Project: IEEE P802.15 Working Group for Wireless Personal Area Networks (WPANs)

Submission Title: [Radio Specification Analysis of Draft FSK PHY]

Date Submitted: [17 January, 2012]

Purpose: [To assist with the definition of the 15.4k FSK PHY]

- Transmit spectral mask
- 25 kb/s M.I. = 1.0

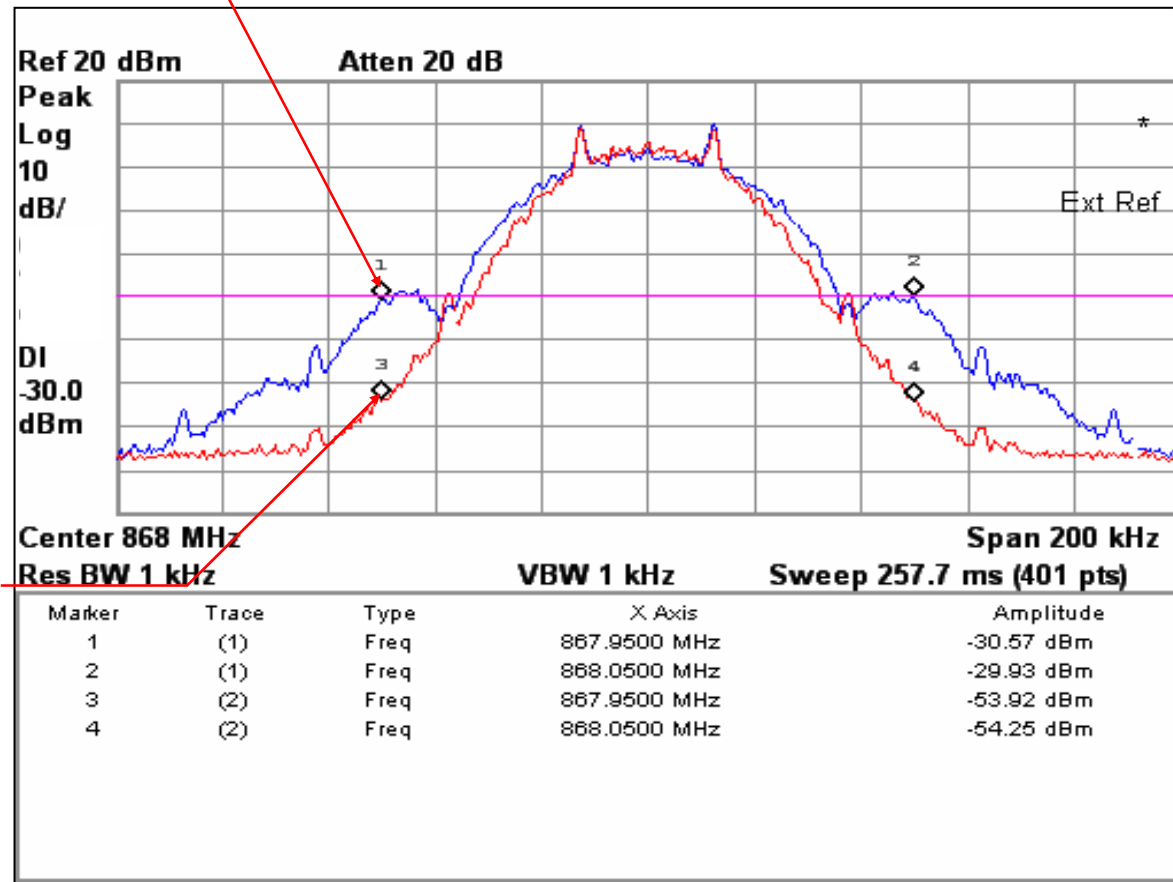
GFSK BT = 1.0
MKR 1, MKR 2 indicate
nom. Mod BW limits for
100 kHz channel spacing
MARGINAL COMPLIANCE

GFSK BT = 0.5
MKR 3, MKR 4 indicate
compliance with ~20 dB
margin

- Transmit spectral mask
- 12.5 kb/s M.I. = 4.0

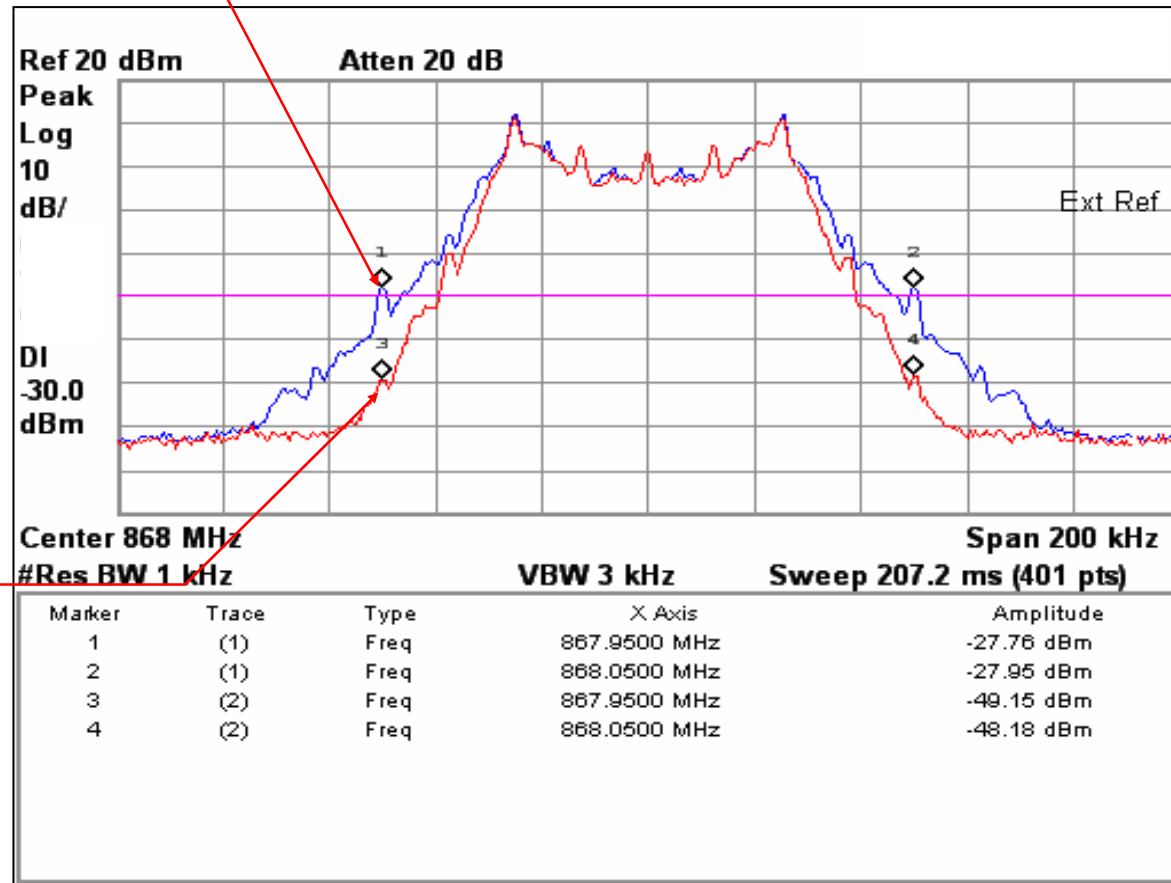
GFSK BT = 1.0
MKR 1, MKR 2 indicate
nom. Mod BW limits for
100 kHz channel spacing
MARGINAL COMPLIANCE

GFSK BT = 0.5
MKR 3, MKR 4 indicate
compliance with ~20 dB
margin

- Transmit spectral mask
- 37.5 kb/s M.I. = 0.5 (Silicon source)

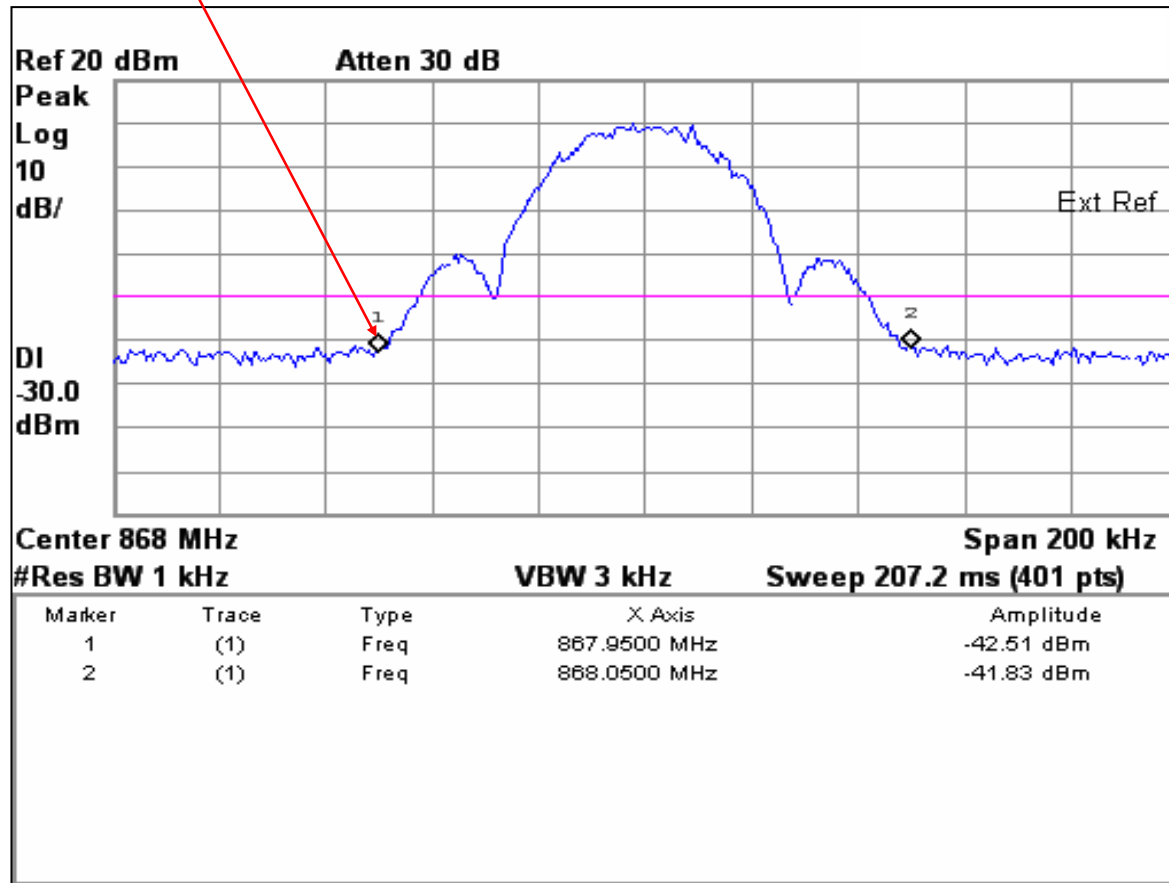
GFSK BT = 1.0
MKR 1, MKR 2 indicate ~10 dB margin!

- Transmit spectral mask
 - For 100 kHz / FHSS in Europe GFSK BT = 0.5 required
 - Increases system requirements on to receiver
 - Define non-specific modulation case to allow mod. BW up to 300 kHz and implement frequency agility (AFA + LBT)
 - “Grey” area as to whether you can still define 100 kHz channel spacing
 - No consistent response based on Notified Body “interpretation”
 - Standardize on 200 kHz channel spacing for sub-GHz FSK PHY channel spacing
 - 15.4g MR-FSK CSM
 - Define non-specific modulation case to allow mod. BW up to 300 kHz and implement frequency agility (AFA + LBT)
 - ETSI TG 28 looking at smart grid utilization in Europe and are taking reference from 15.4g FSK PHY proposals. Would fit some LECIM applications
 - Define PHY more suitable for 100 kHz / FHSS operation
 - e.g. GFSK 12.5 kb/s, Mod. Index = 2.0, BT = 1.0

- Receiver interference rejection
 - Consider the case of 25 kb/s PHY (GFSK BT = 0.5) with a modulated interferer in the adjacent channel

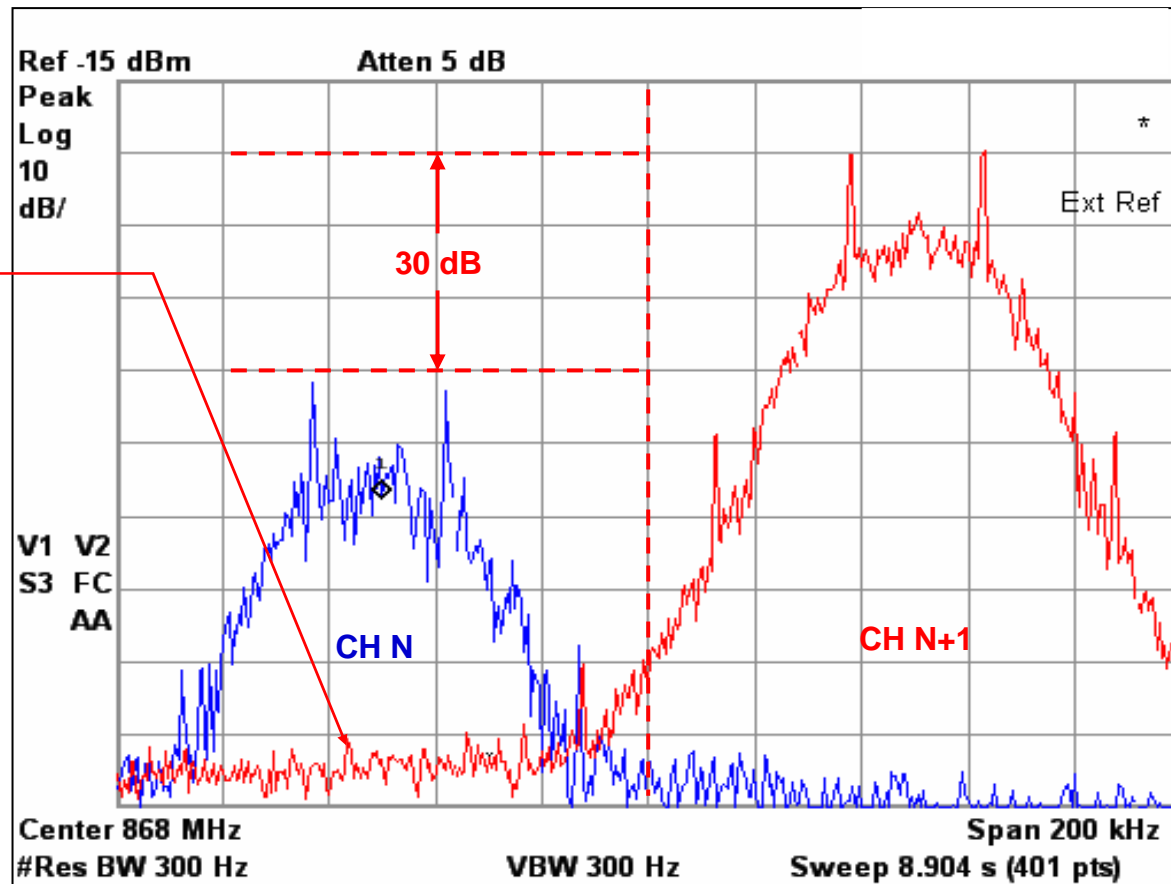
Mod spectrum of interferer (R&S SMIQ) bleeds into wanted channel

- Receiver interference rejection
 - Consider the case of 25 kb/s PHY (GFSK BT = 0.5) with a modulated interferer in the alternate channel

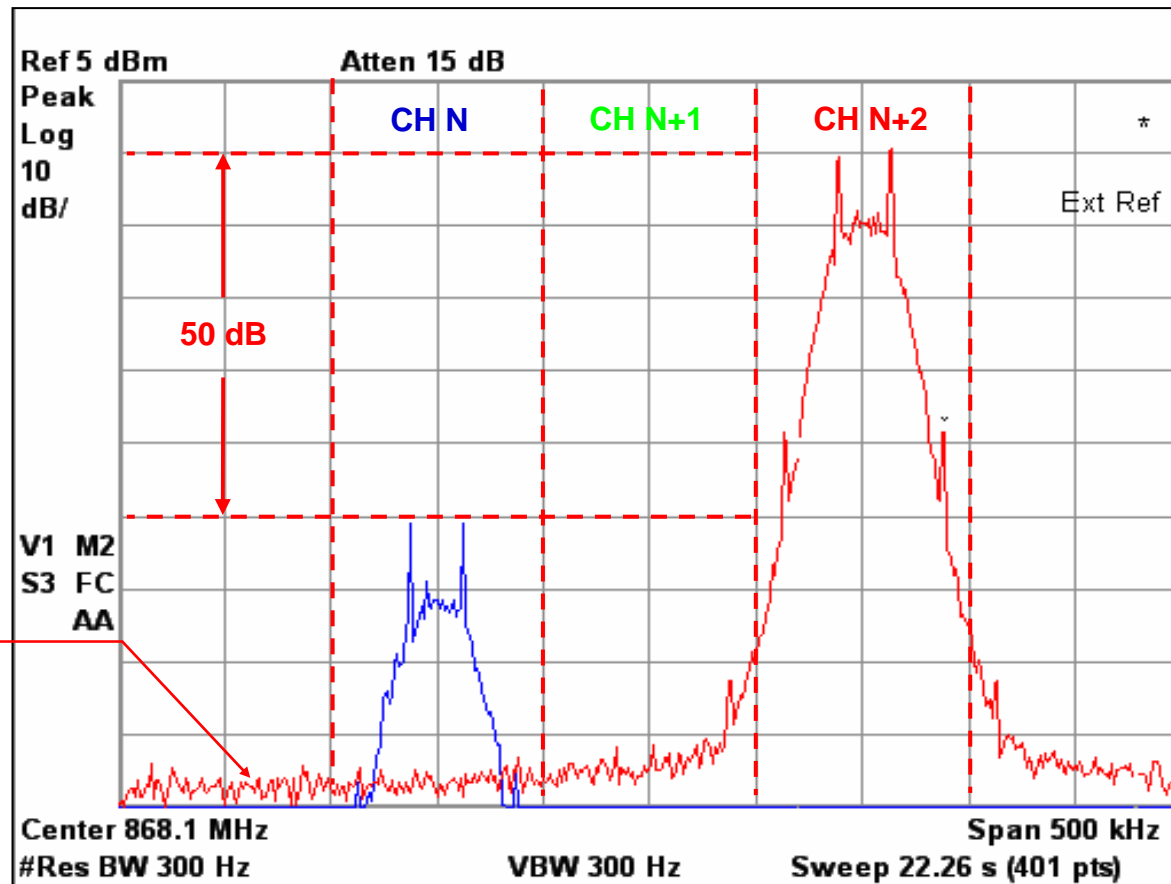
Phase noise of interferer (R&S SMIQ) bleeds into wanted channel
